The Network Rail (Huddersfield to Westtown (Dewsbury) Improvements) Order 19 October 2021

NR/PoE/REB/JP/08 Environment Rebuttal

REBUTTAL PROOF

RELATING TO PROOF OF EVIDENCE KIRKLEES COUNCIL (OBJ/33)

Figure 1-1: Weaving Lane waste facility reconfiguration

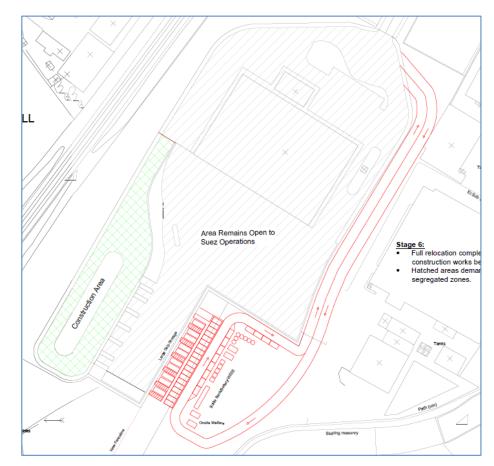
- 2.1.1 Kirklees Council does not raise objection to the design of the reconfiguration of the site. However, Kirklees Council states that the environmental effects should be assessed and mitigated where applicable.
- 2.1.2 The matters covered in this rebuttal are as follows in considering a reconfigured waste site:
 - Temporary works;
 - Ecological appraisal;
 - Tree Cover;
 - Land with contamination;
 - Materials Management;
 - Flood zone 2;
 - River Calder;
 - Council highways approval; and,
 - Consultation.

- 2.1.8 It is my opinion that a single line of trees does not act as noise barrier. The depth in general would need to be 30 metres deep with canopies at every height and in leaf for the whole year to present any sort of effective barrier to noise. This is not the case at the site with tree cover sporadic and in one line of trees.

- 2.1.13 The new access road shown in red on Figure 1-1 sits entirely within flood zone 2 land as designated by the Environment Agency. The road will be designed at current ground level and will mimic drainage from the existing access road with no effects on flood zone 2.

- 2.1.14 The turning circle or waste drop off area at the end of the access road will be raised by approximately 1.7m as requested by Kirklees Council to facilitate safe public depositing of waste into skips. This area is partly in designated flood zone 2 area, but the temporary arrangement is considered to have a negligible effect on flood zone 2 extension with no further assessment required.

1.1.4 In summary, the existing waste skips (shown in grey) adjacent to the construction area in green shading are flipped to the other side of the waste site (shown in red). The existing public access that runs anti clockwise from the waste site entrance and adjacent to the railway is also flipped to run

- 1.1.5 The drop off area will be raised by 1.7m so that waste can be deposited into skips without the need for public stepped access to the skips, in line with Health & Safety requirements.
- 1.1.6 Kirklees Council raises a number of environmental items in their proof of evidence that I will address in this rebuttal.

- 2.1.3 I would like to make clear that the reconfiguration of the site is a temporary requirement covered under the powers in the Order to facilitate the Scheme works and once these works are complete, the site will be returned to the current arrangement.

- 2.1.9 What can be said is that the visual removal of a line of trees has the potential to heighten the perception of increased noise. On completion of the works and returning the site to the original configuration, the area can be replanted, and this re-planting would be included in the LEMP to be submitted to and approved by Kirklees Council. No further assessment for noise effects is required on this basis.

- 2.1.10 In terms of a potential barrier to dust and litter, I do not consider that a single line of trees with gaps act as an effective barrier to dust or litter. The effective controls are established through the current planning controls in place between the operator Suez and Kirklees Council. The LEMP will require the area to be re-planted in the permanent state to replace planting that has been removed.

- 2.1.15 The new location of the skips are located entirely outside flood zone 2 designated land, so no significant environmental effects are identified.

- 2.1.16 As the reconfigured site is a temporary arrangement and sits partly in flood zone 2 designated land, the mitigation required is managed through the CoCP Part A: Section 7: Watercourses. Site-specific controls are established through the implementation of the CoCP Part B and the required Pollution Prevention and Incident Control Plan (PPICP). No further assessment is required.

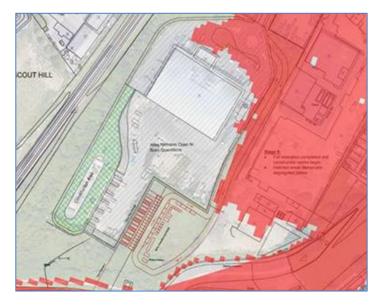
- 2.1.17 The temporary design of the reconfigured site has been checked against the 1% Annual Exceedance Probability (AEP), that is the probability of flooding of 1 in 100 in any given year, with the addition of an allowance for climate change of 50% increase in flow. The extent of 1%AEP plus allowance for climate change is shown in red in Figure 2-1.
- Figure 2-1: 1%AEP plus allowance for climate change at Weaving Lane

- 2.1.18 The access road is at grade and on this basis, though within 1%AEP, this is not significant. Immediately before the turning circle drop off area, the access road starts to climb towards the skip area, so that a very small section of road that starts raising up is within the 1%AEP.
- 2.1.19 This interaction with 1%AEP is minimal and given the road is a temporary arrangement only for the duration of the works, this is considered acceptable to facilitate the Order works.
- 2.1.20 The alternative to avoid any temporarily raised land in proximity to 1%AEP would be to incorporate stepped access to the skip area but this is not considered acceptable on Health and Safety grounds, as described in section 1.1.5, so was not recommended.
